# Concord Middle School

Middle School Building Committee

VE

15 September 2022

## ITEM #81- Reduce size of Gymnasium by 3,500 Square Feet to MSBA Standard (6,000 SF Gym with MIAA Cour

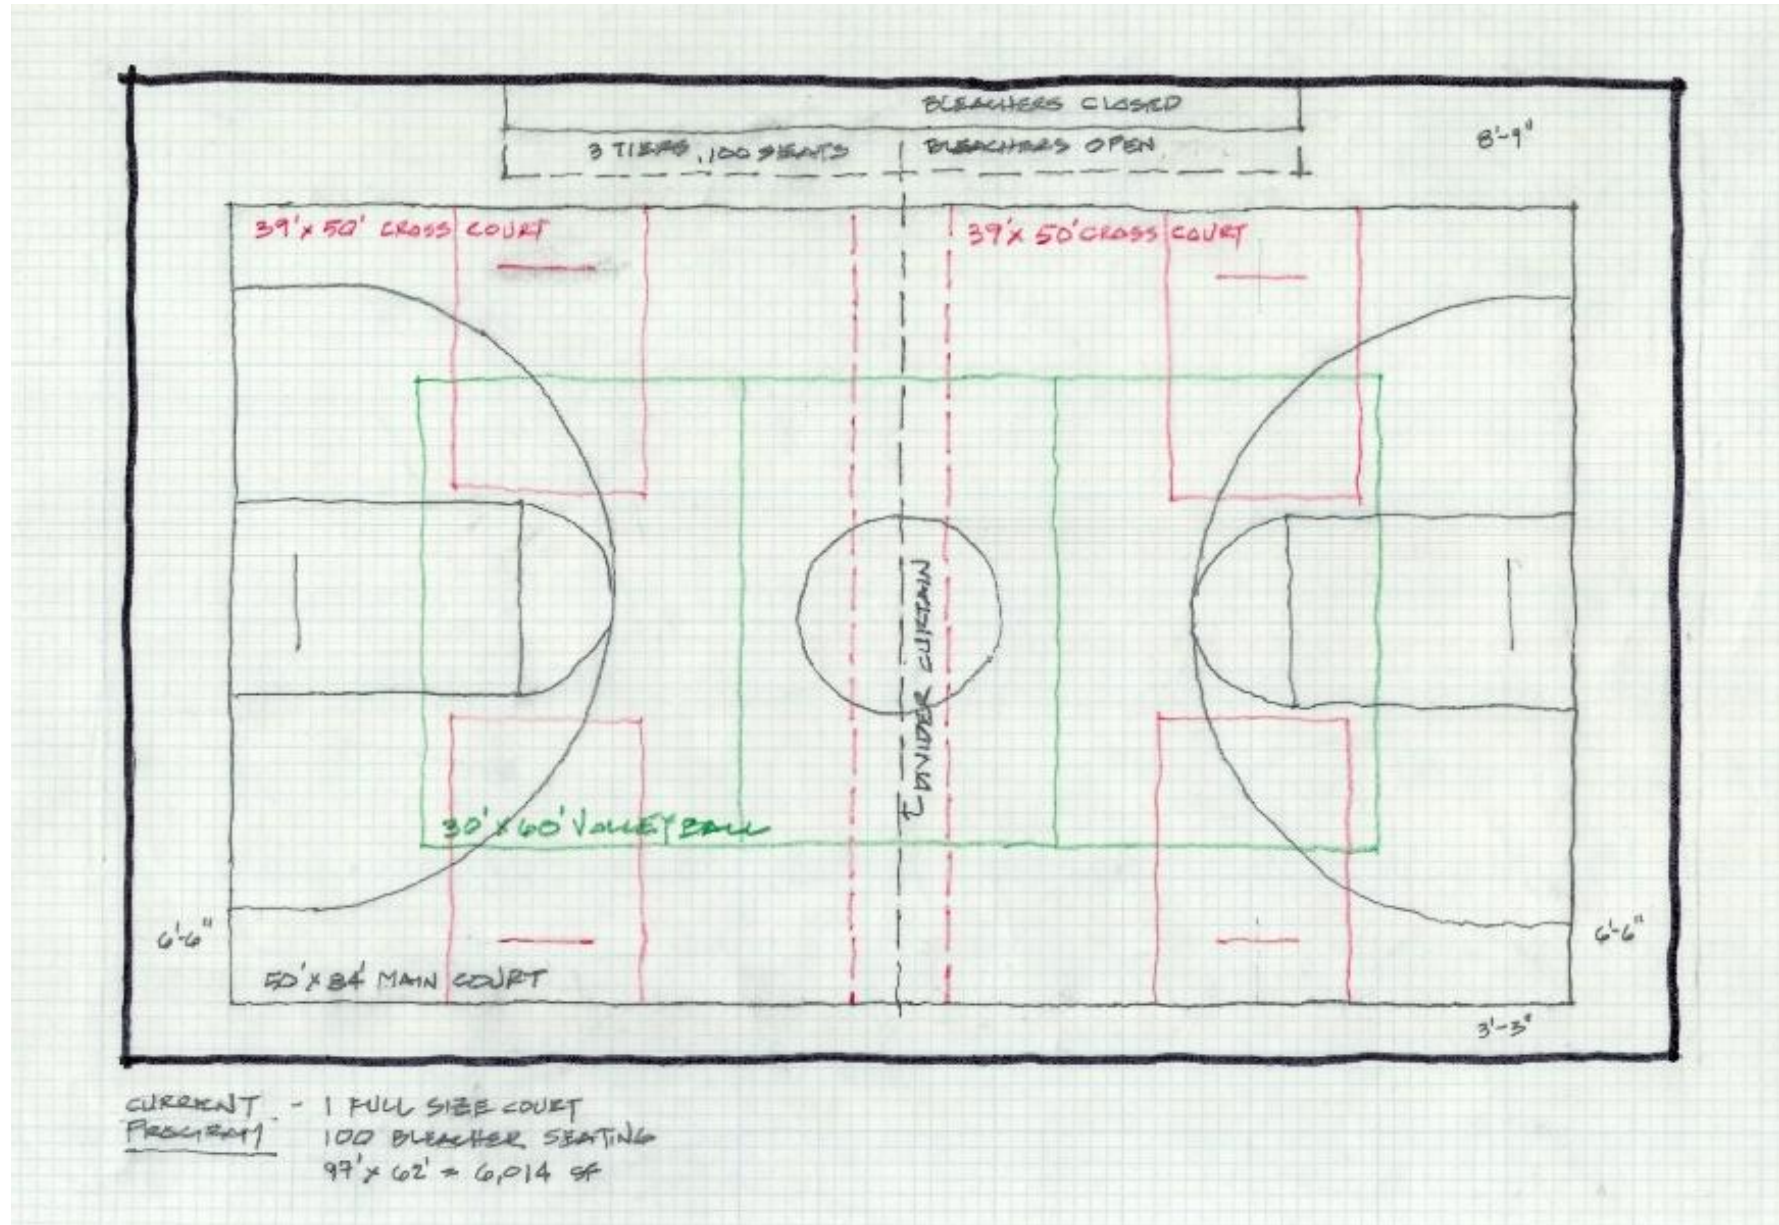
Sketch: 6,000 nsf gym

- One MIAA main
- 39'x50' cross courts
- divider curtain
- 100 bleacher seating
- 2 teaching stations
